Subj: DE07-03- Request to Reduce Street and Right-of-Way width at 2561 G ½ Road.

RE: TEDS Exception No. 07-03, to Reduce Street & Right-of-way Width at 2561 G1/2 Road

DESIGN EXCEPTION #DE07-03

**RE: Traffic Engineering Design Standards (TEDS) Exception
Section 5.1.2, Right of Way, Street Lane Widths, and Street Lengths
Woodridge Subdivision, 2561 G.5 Road**

EXISTING TOPO

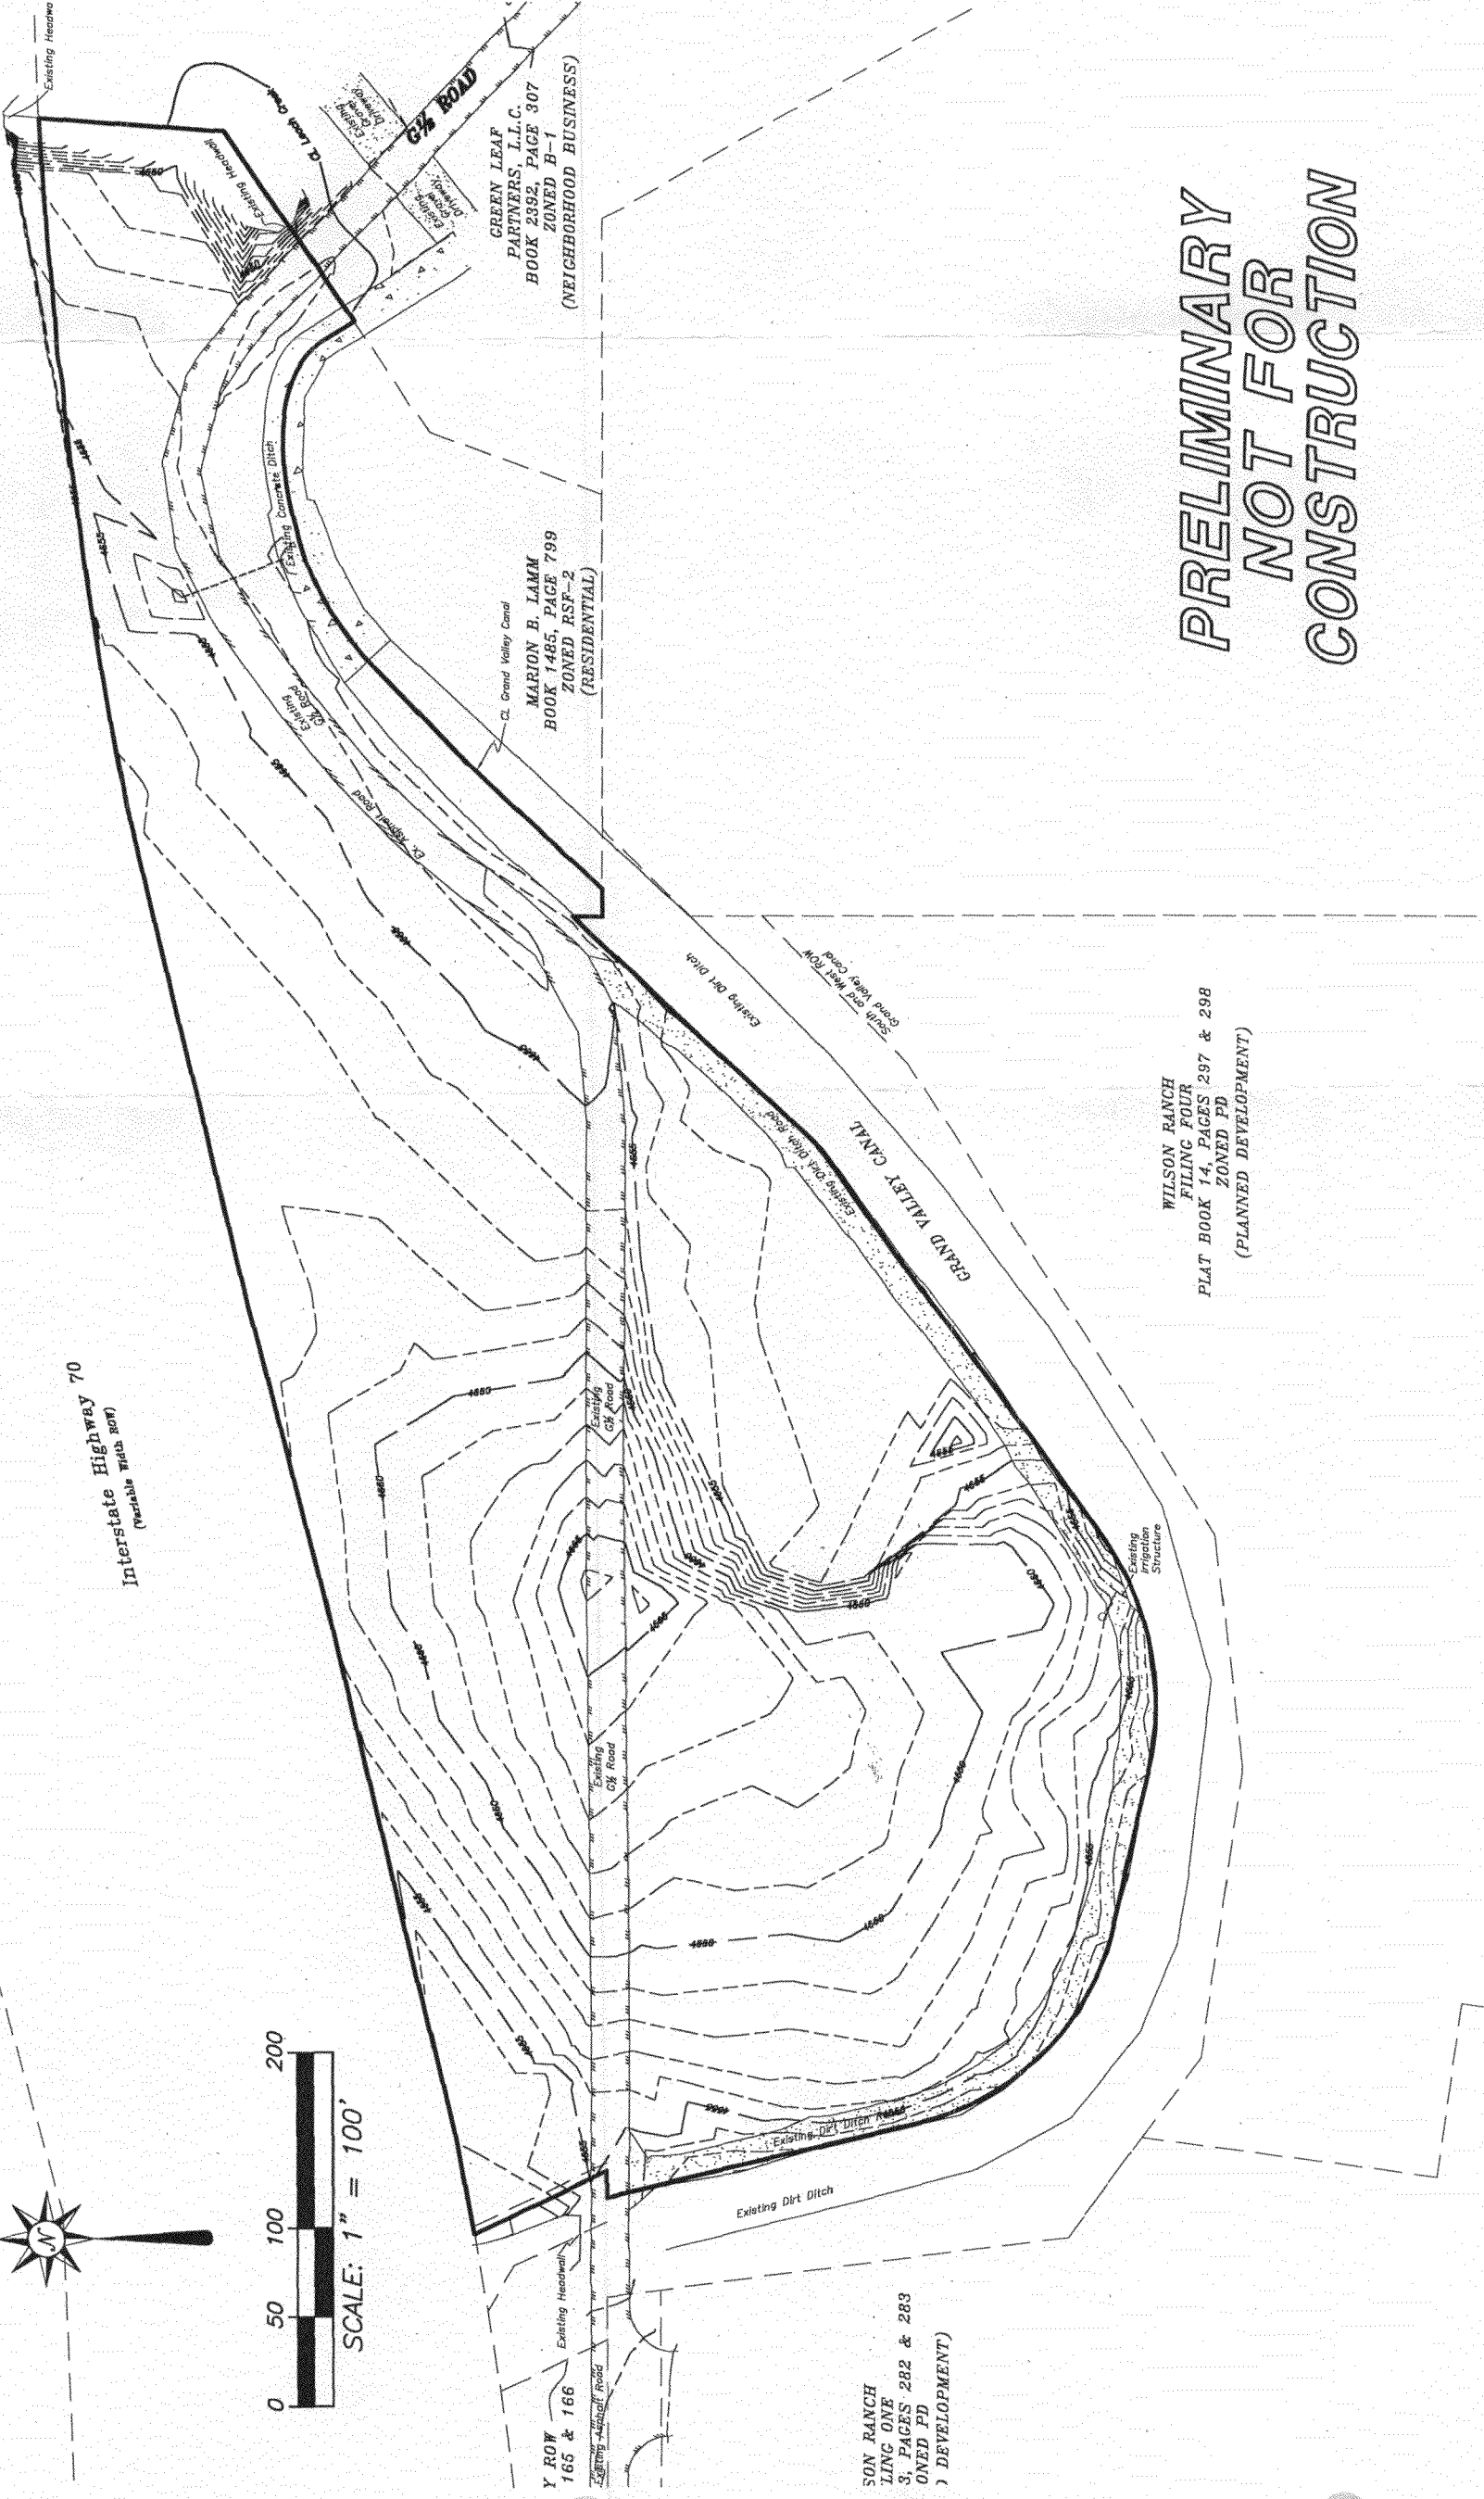
On behalf of the developer, Tierra Ventures, LLC, the following is a formal request for a TEDS exception to Section 5.1.2, Right of Way, Street Lane Widths, and Street Lengths. See Exhibit 1 and 2 for proposed site plan and general topography map that shows the existing G.5 Road.

G 1/2 ROAD
DETAIL

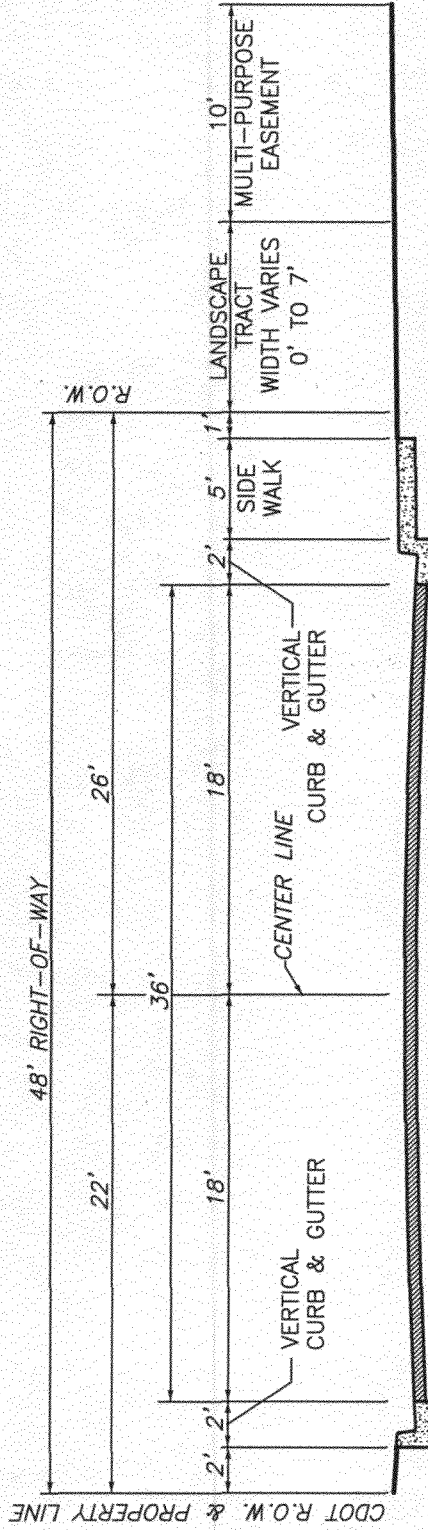
Please find attached the committee's decision on the above request. The Review Committee approved this request with the condition that the sidewalk along the south side be eight feet wide, instead of the proposed five feet. The committee also suggested the developer consider separating this 8-foot walk from the curb and incorporating the multi-purpose easement into the area from the back of curb to the back of walk.

I do not think the city should give up twelve feet of right-of-way, a four foot sidewalk, fourteen feet of north multi-purpose easement and four feet of south multi-purpose easement with no return of public benefit. The applicant should provide some comparable benefit to the public in return for these concessions. I recommend a separated sidewalk along the south side within a 54-foot right-of-way, as possible mitigation. If the bike lanes are eliminated from the pavement area, the sidewalk could become a 10-foot wide combined sidewalk and bike path. Either of these options could incorporate the landscaped strip and the multi-purpose easement within the area behind the south curb and under the sidewalk/pathway.

A TEDS exception is being requested for a non-standard width right of way with sidewalk and multi-purpose easement on the south side of the street. The road classification for G.5 Road is an Urban Residential Collector. See enclosed Exhibit 3 for standard section. The proposed configuration for the new G.5 Road is to have a 48' right of way width instead of the standard 52' right of way. The street will have an attached sidewalk on the south side, and no sidewalk along the north side of the street. No multi-purpose easement is proposed along the north side of the street, as a 10' multi-purpose easement is provided along the south right of way of the street. The developer is only required to construct ½ street improvements on the south side of G.5 Road according to City Code. At the general meeting, City staff said they would allow a shoulder and bar ditch on the North side of G.5 Road. However, the developer feels it is in the best interest of the public and the project to construct curb and gutter along the North side of G.5 Road. A multi-purpose easement is not proposed on the north side of the road, since all existing development, except for Bookcliff Gardens to the east of this project, would be to the south of G.5 Road. The developer is proposing to provide a separate 7' landscape tract, that will be maintained by the homeowners association, along the south right of way to add street landscaping and a buffer to the development. A 10' multipurpose easement along the south side of G.5 Road will be adequate to provide utilities, as all utility service connection to the lots will be provided from the 14' easement adjacent to Woodridge Court (along the front of the lots). See Exhibit 4 for proposed section of G.5 Road.

The proposed configuration with the 48' right of way width and no sidewalk or 14' multi-purpose easement on the north side of the road allows the G.5 Road alignment to be moved closer to the CDOT Right of Way which allows for more developable area south of G.5 road.

I recommend approval of the requested Design Exceptions to Section 6.1.1 to allow the proposed elimination of the sidewalk and multi-purpose easement along the north side of the street section with appropriate mitigation as described above.
